## ADDENDUM NO. 1

**Construct New Columbarium Wall  
Bloomfield Veterans Cemetery  
Bloomfield, Missouri  
State Project No.: U2001-01  
VA Project No.: FAI # MO-16-14**

**Bid Opening Date: 1:30 PM, Thursday, May 28, 2020 (Not Changed)**

**REVISION TO PLANT LIST, DRAWING SHEET LP101**

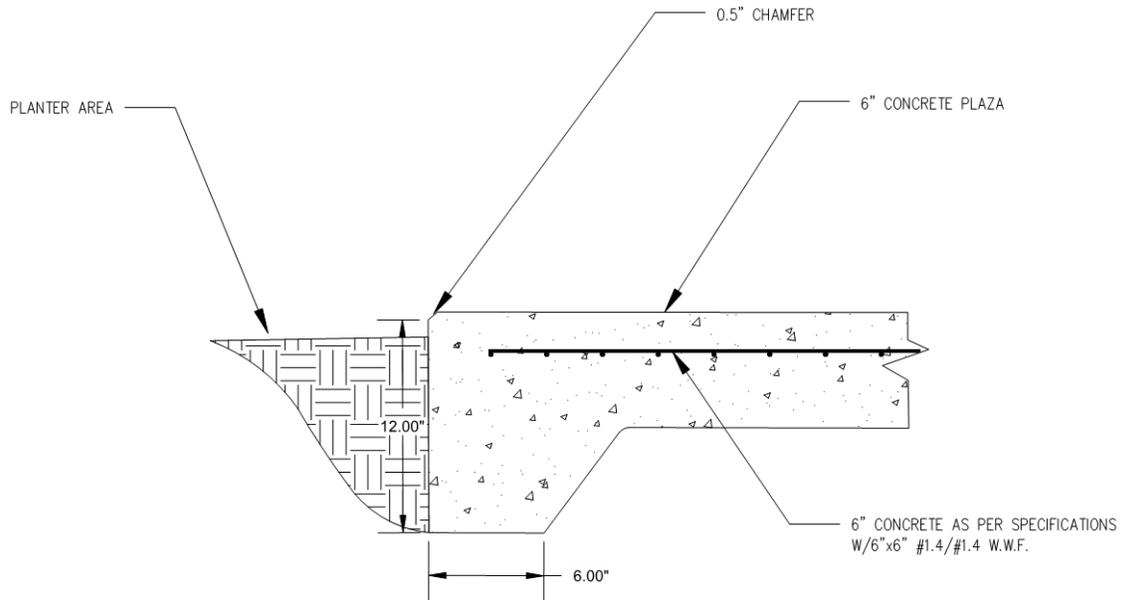
1. Sheet C2.0
  - a. ADD Note to Detail 2 as shown on the attached revised detail.
2. Sheet LP101
  - a. REVISE Plant List as shown on the attached revised table.
3. Sheet A101
  - a. REVISE Floor Plan Keyed Note 11 as shown on the attached revised partial table.
4. Sheet A102
  - a. ADD Notes and Dimensions to Detail 1 as shown on the attached revised detail.

<b>SHRUBS</b>					
DCB	8 <b>11</b>	DWARF CRANBERRY BUSH	<i>Viburnum opulus</i> 'Nanum'	5 gallon, 2.6'-3.0' O.C.	Container
NIH	12	NORDIC INKBERRY HOLLY	<i>Ilex glabra</i> 'Chamzin'	5 gallon, 2.6'-3.0' O.C.	Container
WGB	10	'WINTER GEM' BOXWOOD	<i>Buxus micro. var. koreana</i> 'Winter Gem'	5 gallon, 2.6'-3.0' O.C.	Container
